APPENDIX A – RESPONSE TO GOVERNMENT AGENCIES AND ORGANISATIONS

SSD 9210 – Proposed Saints Peter and Paul Assyrian Primary School
17-19 Kosovich Place, Cecil Park (Lot 2320 & 2321 DP 1223137)

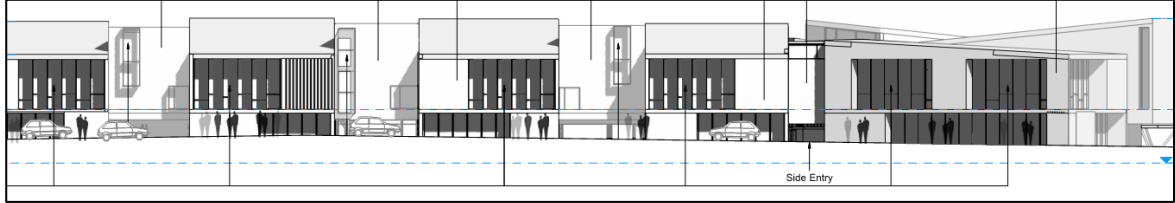
Planning	
Concern is raised that the proposed building design being a single mass, located in close proximity to the eastern boundary, is not considered to be in character with the rural locality. It is noted that the eastern elevation of the building is approximately	The consolidation of internal learning areas and other internal facilities within a single, two (2) storey built form enables unbuilt-upon area and landscaping to be maximised over the site. Through the provision of vast open spaces and extensive landscaping, the site responds to its rural surrounds and maintains a 'green' and vegetated character.

<i>Issues Raised by Agencies and Organisations</i>	<i>Proponent's Response</i>
	<p>to FDCP and offers significant building separation from the adjoining property. Extracts showing the eastern elevation are provided at Figure 1-2 below.</p> <p>Therefore the design of the eastern elevation and eastern boundary setbacks are <i>not</i> considered to be in any way 'inappropriate'.</p> <p>Similarly, the proposal would <i>not</i> be inconsistent with the objectives of the RU4 zone. Council have specifically queried the proposal's consistency with the following zone objective:</p> <p><i>To ensure that development is sympathetic to the rural environment and minimises risks from natural and man-made hazards.</i></p> <p>As described in the above paragraphs, the development is <i>sympathetic to the rural environment</i> on the following basis:</p> <ul style="list-style-type: none">▪ The design integrates with the rural environment through maximising open space, unbuilt-upon area and landscaping over the site.▪ The appearance of the bulk and scale of the built form has been managed through façade articulation, massing of different building envelopes, treatment of level changes, modulated roof forms, setbacks and landscaping.▪ Vegetation planting adjacent to the site boundaries will soften views toward the site, riparian planting will enhance the environmental quality of the corridor in the site's west, and more than half of the site will be retained as open space.▪ Canopy trees proposed to be planted will extend above the height of the roofline, thereby assisting the scale of the development to integrate with its landscape.▪ The amenity of surrounding rural properties has been safeguarded through generous boundary setbacks, extensive landscaping and planting of canopy trees.

Figure 7. Proposed Queuing (McLarens 2018)

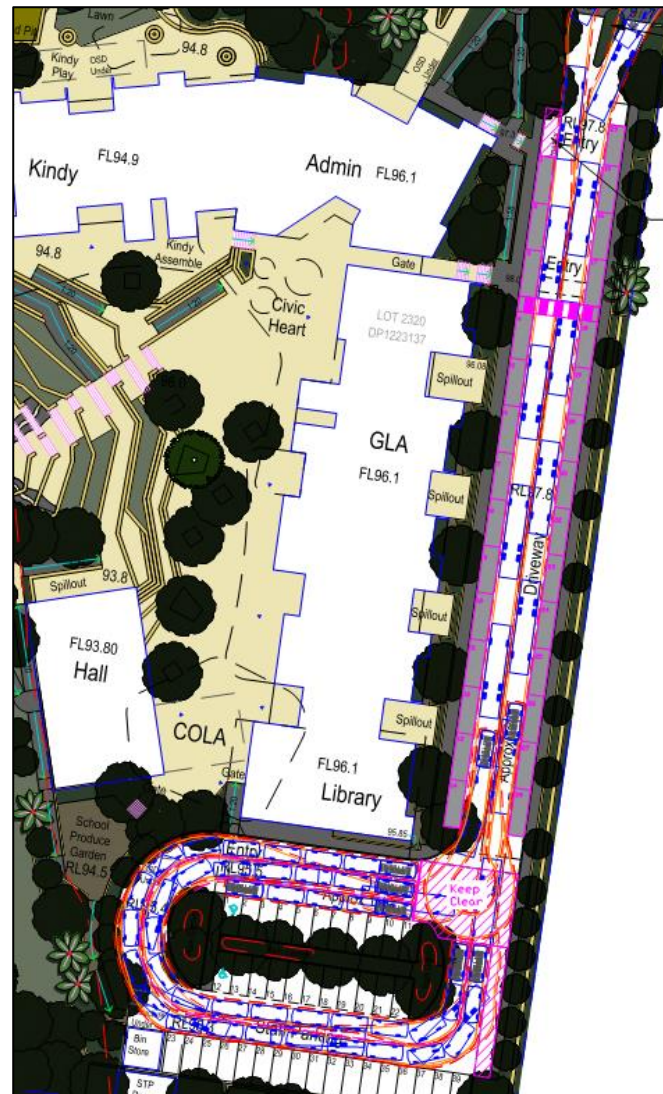
<i>Issues Raised by Agencies and Organisations</i>	<i>Proponent's Response</i>
	 <p>Figure 6. Eastern Boundary Landscaping (Arterra 2018)</p>
<p>The proposed 30 kiss and drop off spaces is unlikely to be sufficient in order to accommodate up to 665 school children and staff onsite. This will likely result in unacceptable queuing and parking within Kosovich Place.</p>	<p>It is noted that the 30 kiss-and-drop spaces are intended to accommodate the drop-off and pick-up of the <i>630 students</i> proposed for the school. Staff would be separately accommodated by the staff car park proposed in the south-eastern corner of the site.</p> <p>The number of kiss-and-drop spaces and proposed queuing arrangements have been designed in conjunction with a qualified Traffic Engineer (refer Traffic and Parking Impact Assessment at Appendix 13 of the original SSDA). The following provides a summary of the utilisation of kiss-and-drop spaces and maximum queue lengths. The results demonstrate that the parking demands of the development and all queuing can be accommodated within the site.</p>

<p>To ensure the proposed kiss and drop facilities operate with high levels of efficiency and safety, the following management practices will be implemented:</p> <ul style="list-style-type: none">▪ Traffic control by school staff at internal pedestrian crossing locations;▪ Traffic control by school staff to direct queued vehicles into vacant kiss and drop spaces;▪ Organisation of students into general kiss and drop areas by year-group to speed pick-up operations;▪ Assistance of school staff to load vehicles with children and bags. <p>Full details are provided in the Traffic and Parking Impact Assessment at Appendix 13 of the original SSDA. The following figure also provides a visual demonstration of the proposed internal queuing arrangements.</p>	Table 2. Queuing Analysis (McLarens 2018)			Phase	Estimated Vehicles in Kiss-and-Drop Spaces	Estimated Queue Vehicles	Stage 1 Development			Prior to pick up	30	5	During pick up	3	0	Final Development			Prior to pick up	30	36	During pick up	7	0
Table 2. Queuing Analysis (McLarens 2018)																									
Phase	Estimated Vehicles in Kiss-and-Drop Spaces	Estimated Queue Vehicles																							
Stage 1 Development																									
Prior to pick up	30	5																							
During pick up	3	0																							
Final Development																									
Prior to pick up	30	36																							
During pick up	7	0
